RE: ITEM NO.1: DA NO.629/2023 – 123 EPSOM ROAD, CHIPPING NORTON

Planning Bricks act on behalf of the Applicant (ArtMade Architects) in relation of DA No.629/2023 for the demolition of existing structures and construction of a 120 place child care centre with basement parking at 123 Epsom Road, Chipping Norton. The DA is due to be considered at the Local Planning Panel (LPP) meeting on 24 June 2024.

4 **ACOUSTIC FENCE DETAIL 3**
1 : 50

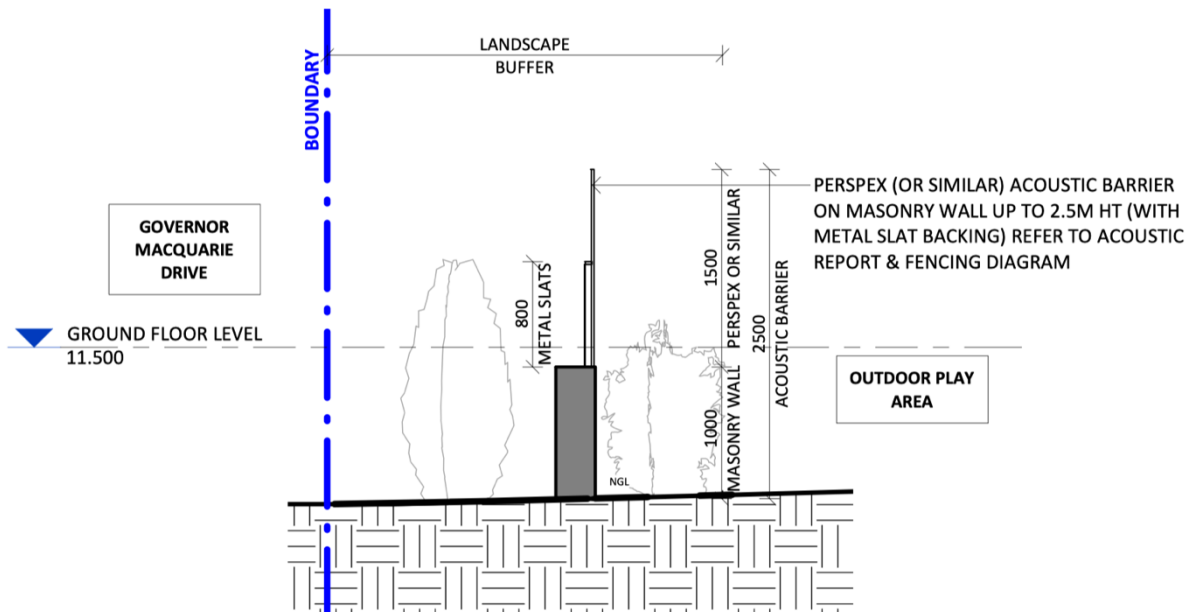
The report to the LPP raises concerns with the location of outdoor play area 2 close to the intersection of the roundabout and what is stated as a concern with heavy and high-speed vehicles. The report requests that:

The applicant is to provide specialist advice (traffic engineer, civil engineer, Safety by Design consultant and/or other) to justify the arrangement of the current design and how children’s safety and mitigation measures have been incorporated into the design, particularly the outdoor play areas and playrooms fronting Governor Macquarie Drive and the roundabout.

As such there has been a low incidence of accidents at the intersection. Nonetheless, the proposal has sought to provide safety fencing to the outdoor area closest to the intersection (outdoor play area 2). Noting that outdoor area 2 is setback 11.5m from the boundary with Epsom Road and 3m from the northern boundary of the site (and 16m from the current alignment of Governor Macquarie Drive).

Outdoor area 2 is provided with 2.5m high fence consisting of a 1m high, 0.3m wide , masonry wall, with a 1.5m Perspex fence above which has a 0.8m high metal slat backing. A section of the proposed fence is provided below.

Overall, given the low occurrence of accidents on the roundabout, the setback of the outdoor play area from the intersection and the proposed provision of a solid fence, the proposal has addressed the safety of the outdoor play space. Notwithstanding, if the LPP were of the view that additional safety measures are required, a condition of consent requiring bollards in front of the outdoor spaces (within setback area) would be accommodated. Similarly, if there are concerns with the small proportion of outdoor area 3 adjoining Governor Macquarie Drive (located 30m from Epsom Road), a condition requiring a 1m high masonry fence and/or bollards could also be accommodated. It is also relevant to note that the play areas are setback beyond the existing Date Palms located on the site and within the road reserve.
